WORKS DESIGN TATA STEEL

DETAIL		MAIN DRIVE SHAFT & SPROCKETS		DF PLATE CONVEYOR	
DRG. NO.	PA-16884	REV.	C	DRG. NO.	PA-16884

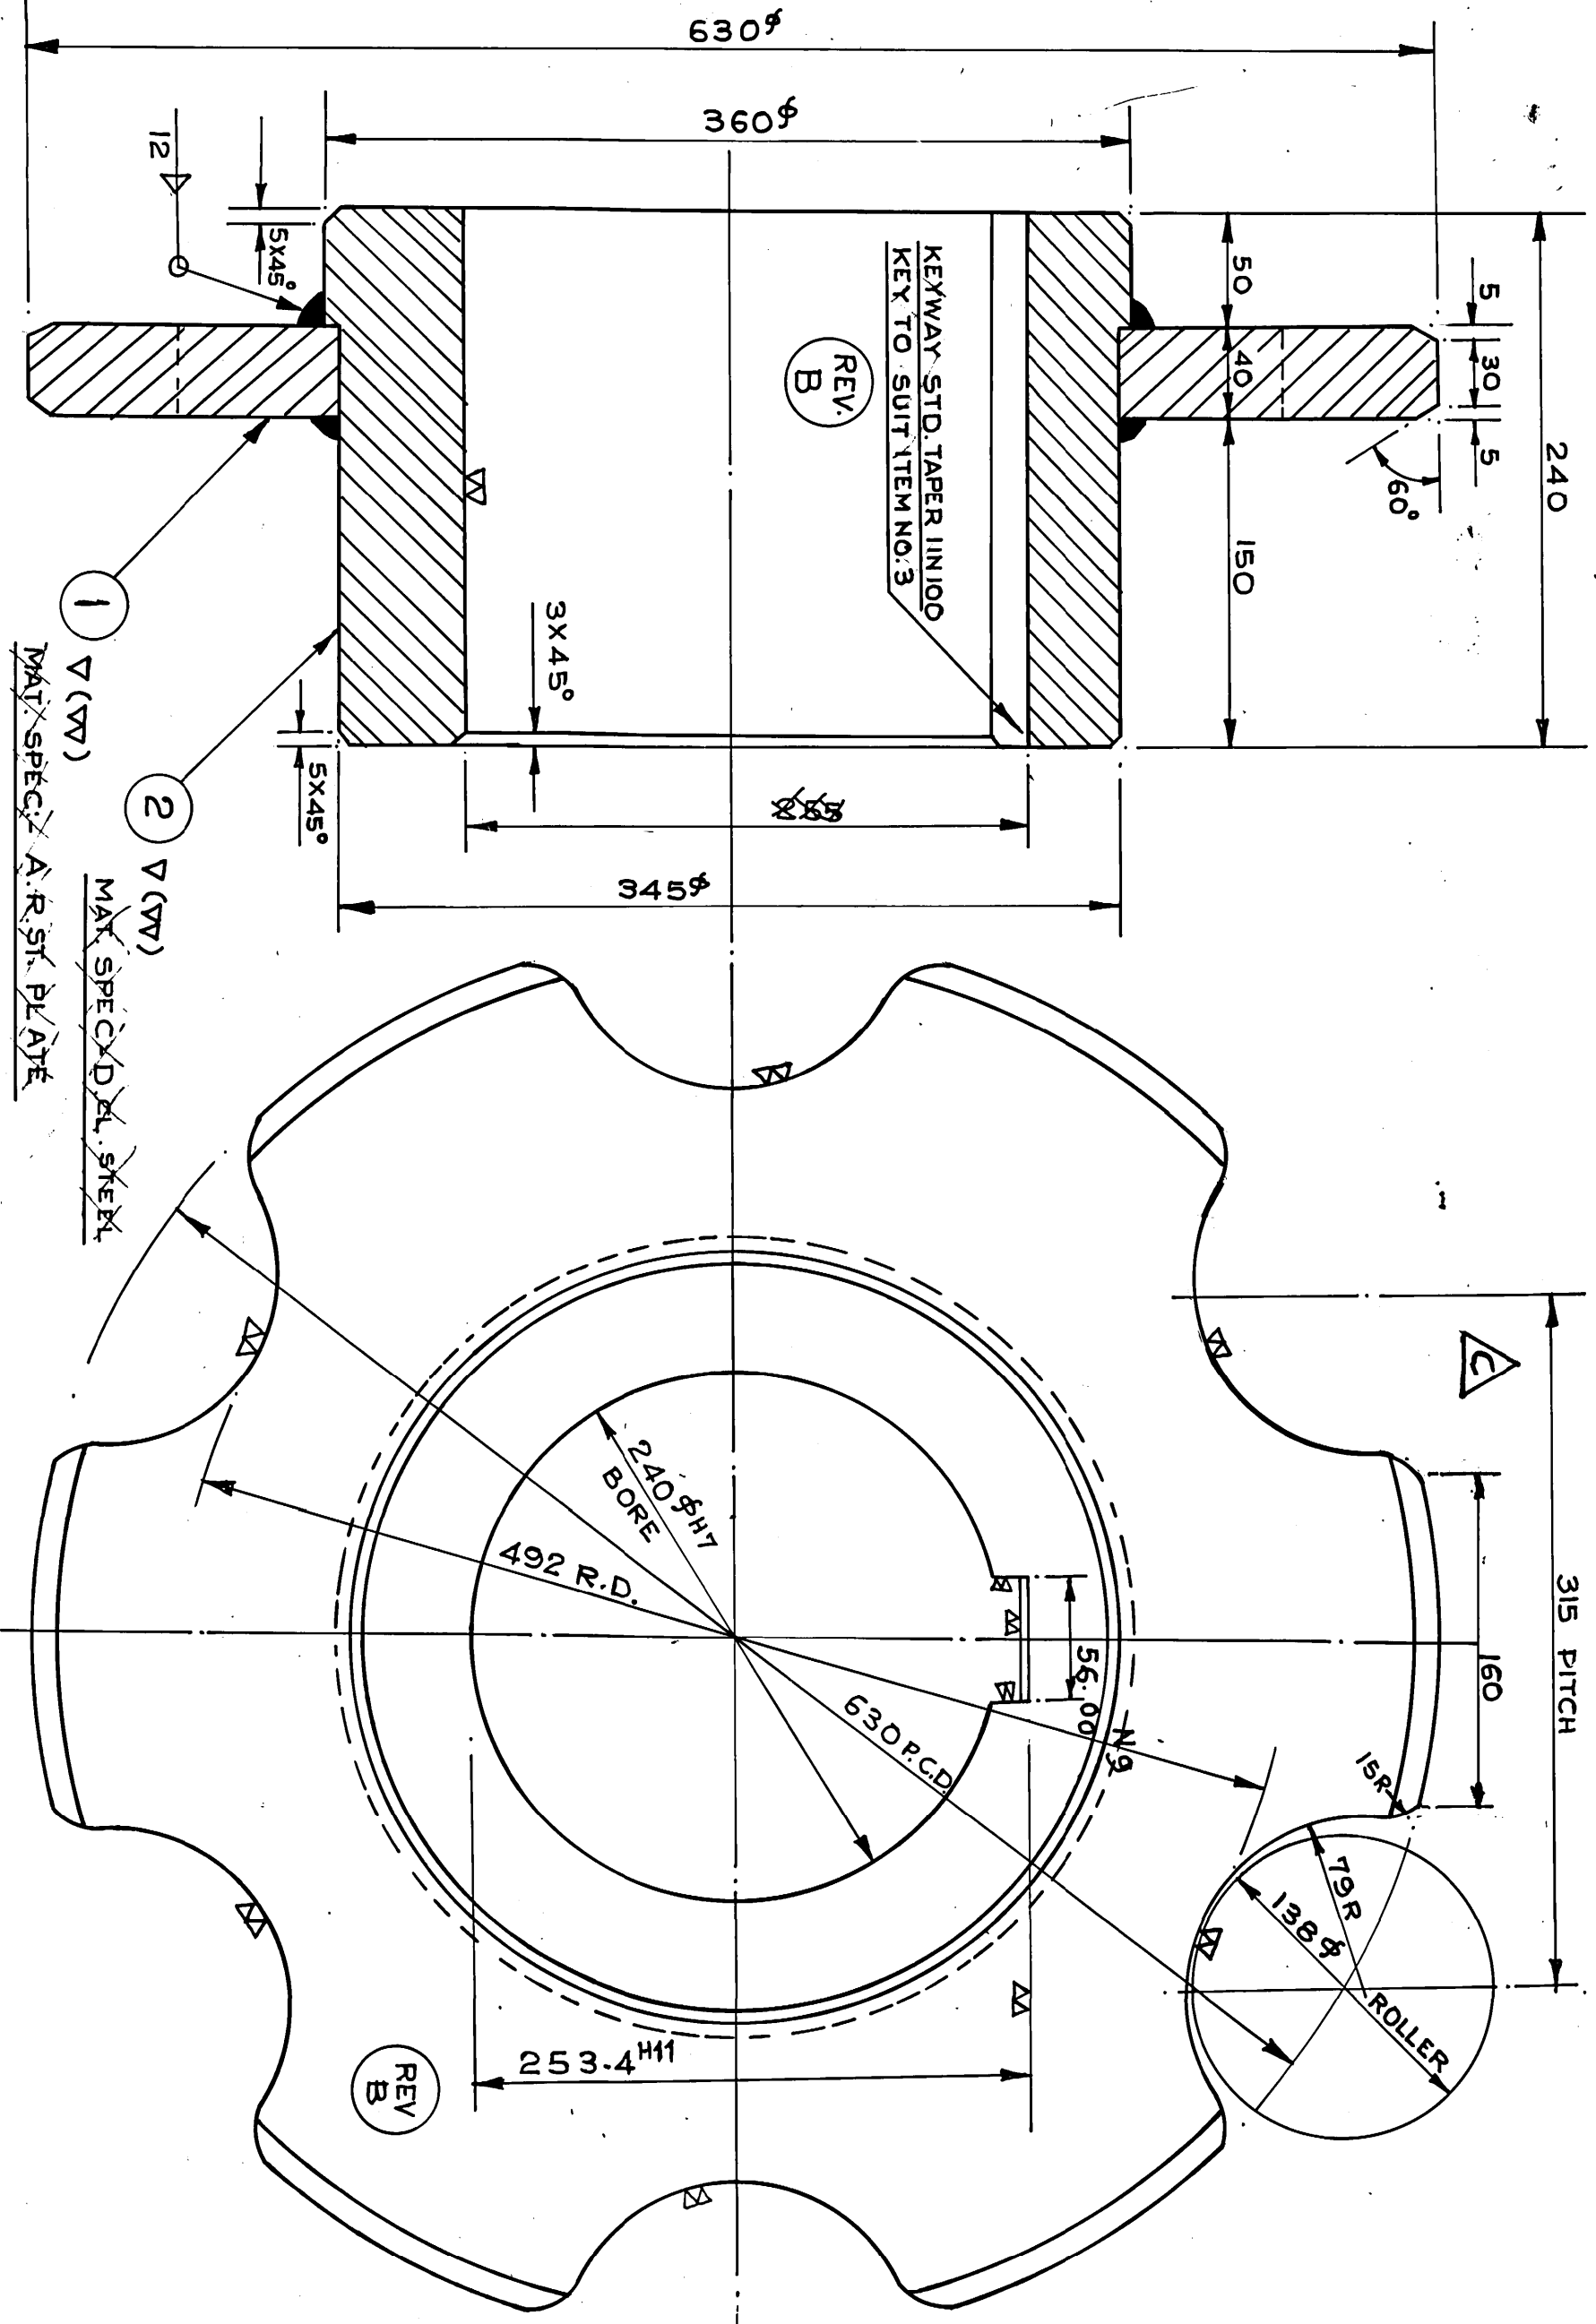
REV. B FOR MOD. SHAFT SEE DRG. NO. PB-34180

REV. A MK-0. TOTAL NO. OF TEETH = 6

REV. A MAT. SPEC. FOR ITEM ① - 15:1570 C45 OR AR-45 OR 15:1570-40 CR. (CR RAIL R) CUT. N. & M/C. TOOTH TO FLAME HARDEN, TEMP. TO 401 SHRC AND GRIND. FOR ITEM ② - 15:1875 C14 F.N. & M/C.

REV. B FOR MOD. SHAFT SEE DRG. NO. PB-34180

DIM. 160 OF MK-0 CORRECTED		R.C.		BY	
C	4-5-16	ITEM NO. 3 DELETED KEYWAY OF MK-0 REVISED CROSS REF. TO PB-34180	CHD	APR	
B	5-10-68	MAT. SPEC. OF ITEM ① & ② ALTERED.			
A					
NO.	DATE	REVISION	BY	CHD	APR
